Shell Oil Products

September 6, 2016

Re: Portland Harbor Proposed Plan

Following please find questions and comments on EPA's Proposed Plan for the Portland Harbor Superfund site.

Table 4.1-1

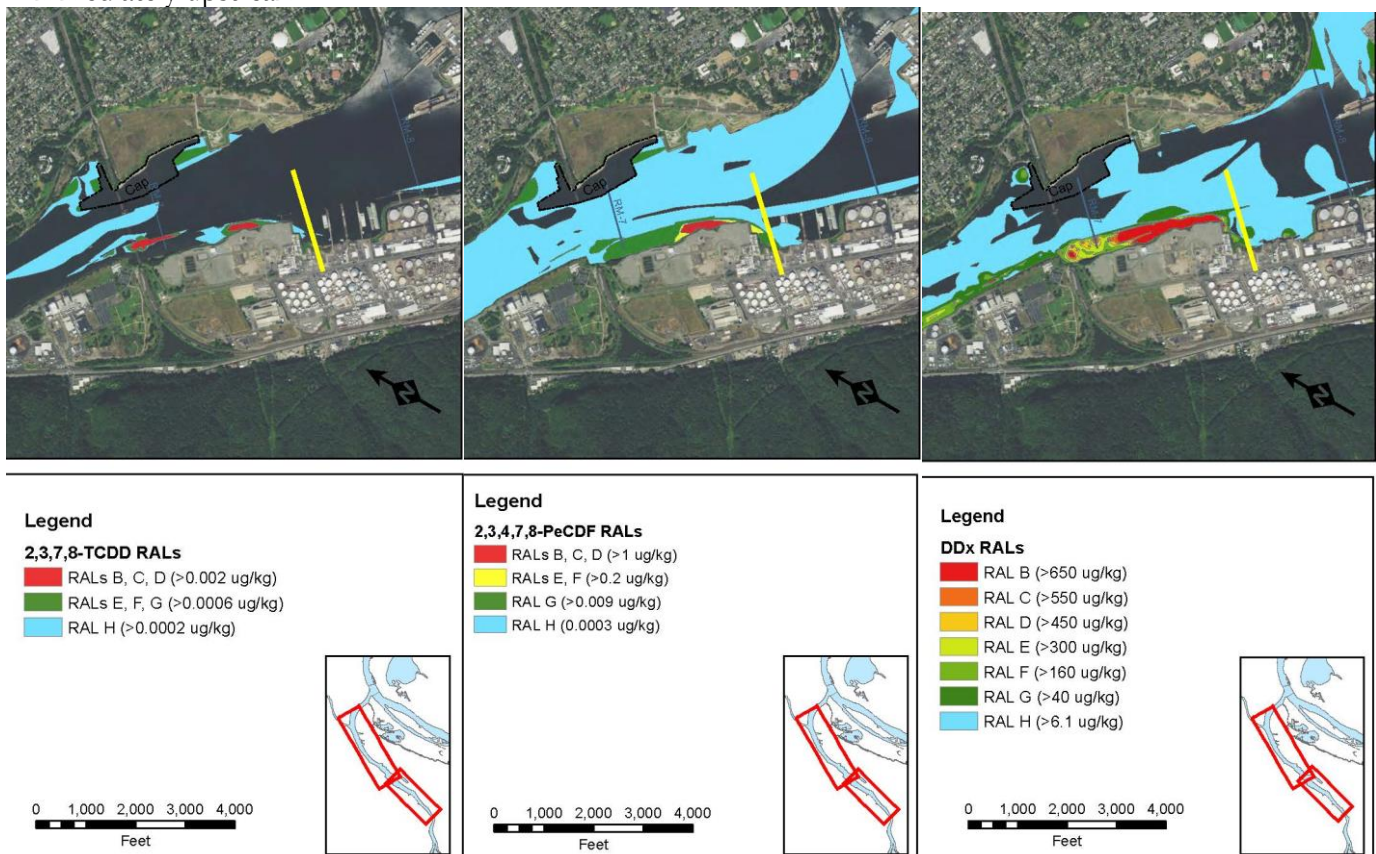
2. Please provide clarification on how the sediment decision unit (SDU) boundaries/location, type/basis, and COCs were determined. These are listed on Table 16 of the Proposed Plan and Table 4.1-1 of the 2016 FS and (reproduced below).

Section 3.4.1.1 of the 2016 FS (Page 3-7) states "*Focused COCs are those that the distribution encompasses the majority of the spatial extent of contaminants posing the majority of the risks as identified in the baseline risk assessments. The focused COCs are only used for the development of SMAs.*" This does not explain how the focused COCs were further narrowed for the individual SDUs.

3. Multiple apparent errors also appear in the table reproduced above, which should be corrected. If they are not errors, please provide justification for each of the following:

- a. Why are several SDUs listed as “Focused COC-based” but have multiple COCs (RM4.5E, RM6.5E, RM11E, RM7W and RM9W)?
 - b. Why is DDx included in the COC list for RM3.9W and RM5W, when DDx is omitted from RM6W? The DDx source is upstream at RM7W and decreases downstream (see panel 3 of Figure D9-3c). It appears that the only focused COC for SDUs RM3.9W and RM5W should be PAHs.

- c. Why don’t the lengths of the SDUs match the river miles (RMs) in the “Location” column of the table? For example, SDUs RM4.5E and RM5.5E are both listed as being 0.9 mile in the “Length” column, but the “Location” column has one SDU listed as 0.8 mile long (RM 4.2 to 5.0) and the other as 1.0 mile long (RM 5.0 to 6.0).

- d. Why do SDUs RM3.9W and RM5W have “Benthic Risk Area” instead of river miles in the “Location” column? The EPA selected 10 times the Preliminary Remediation Goals (PRGs) as an indicator of benthic risk, but essentially no area exceeds this indicator in SDUs RM5W or RM3.9W (Figure 4.2-29 of the 2016 FS). Greater benthic risk is found in other SDUs that are not listed as “Benthic Risk Areas”.

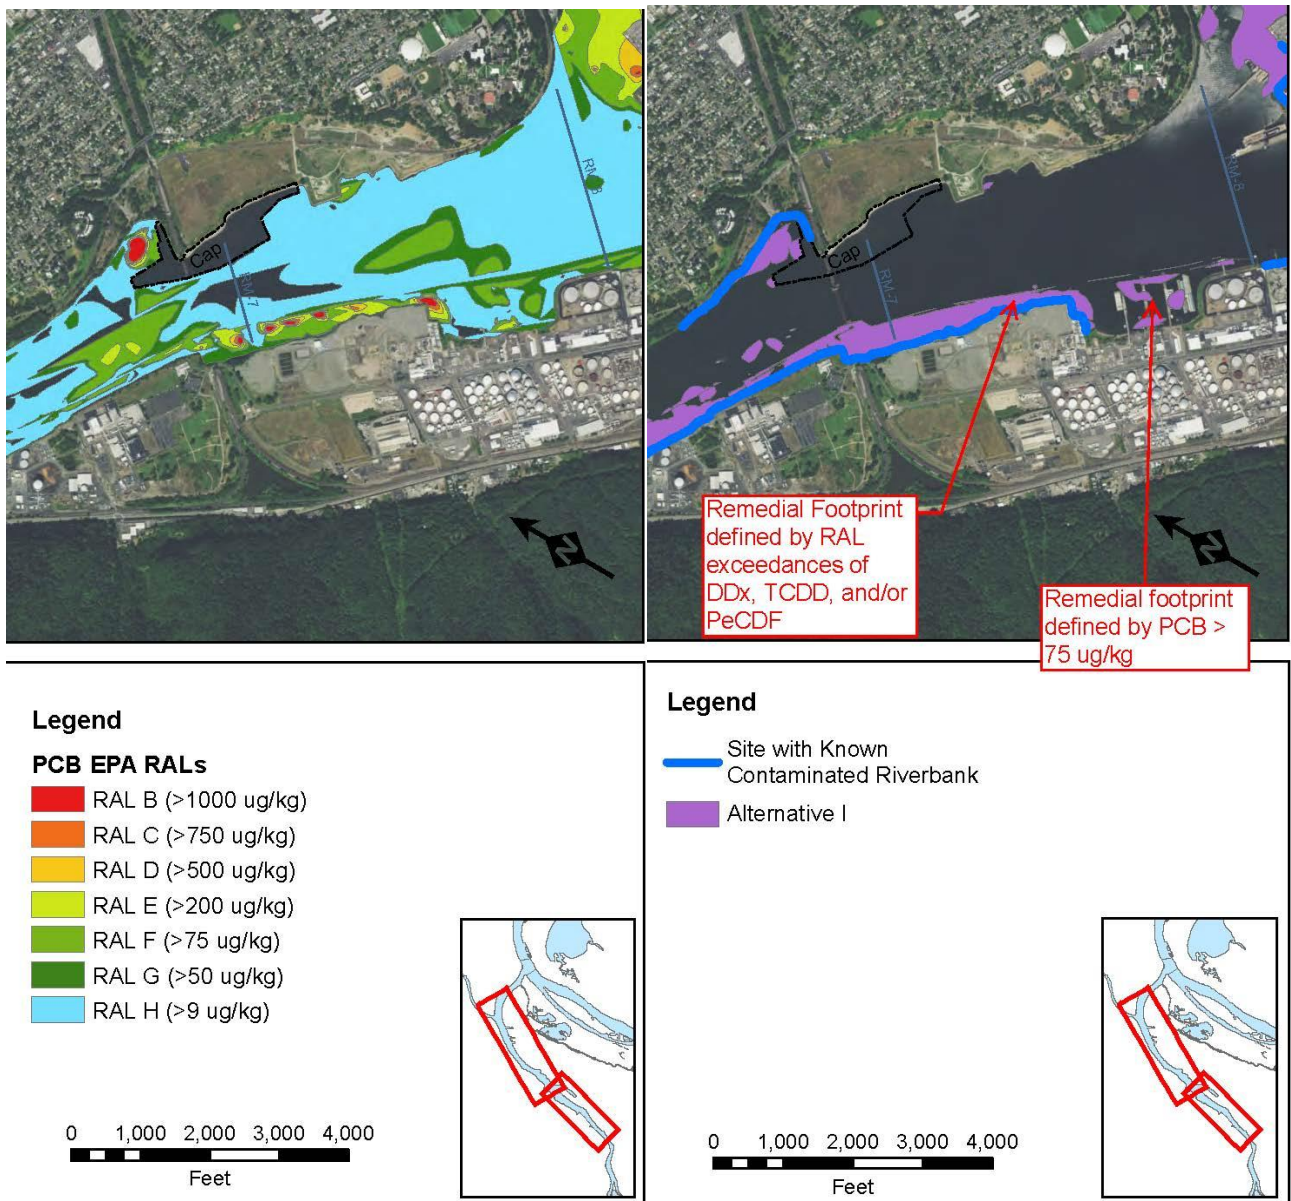
5. If the inclusion of Willbridge Cove in the Arkema SDU was purposeful, then it appears that the assignment of a PCB RAL of 75 ug/kg to Willbridge Cove was an unintended consequence of assigning Alternative F RALs for SDU RM7W. PCBs were not identified as a focused COC for SDU RM7W. However, as can be seen by comparing Figure 3.4-7 and 3.4-14h from the 2016 FS (excerpts reproduced below), the remedial footprint beneath the docks in Willbridge Cove is only due to PCB concentrations exceeding 75 ug/kg – not due to RAL exceedances of the RM7W focused COCs.

Since the Proposed Plan assigns the PTW RAL of 200 ug/kg for PCBs will be assigned to all portions of the river not included in individual SMAs (Proposed Plan, Figure 9), the remedy will be adequately protective in Willamette Cove, even if Willamette Cove is not included in an individual SMA. As discussed above, no other focused COCs exceed Alternative E RALs (see 2016 FS Figures 3.4-7 through 3.4-12).

The assignment of a PCB RAL of 75 ug/kg to Willbridge Cove is inconsistent with the assignment of a PCB RAL of 200 ug/kg to the majority of the River, including immediately upstream of Willbridge Cove. This is in conflict with the NCP and CERCLA requirement that the selected remedy demonstrate “long-term effectiveness and permanence.” Downstream sediment transport will bring sediments with total PCB concentrations as high as 200 ug/kg to Willbridge Cove, recontaminating any areas previously remediated to 75 ug/kg PCBs.

If this was not an error, please provide justification for the assignment of a total PCB RAL any lower than the upstream RAL of 200 ug/kg, and an explanation of how this is consistent with the NCP requirement for long-term effectiveness and permanence.
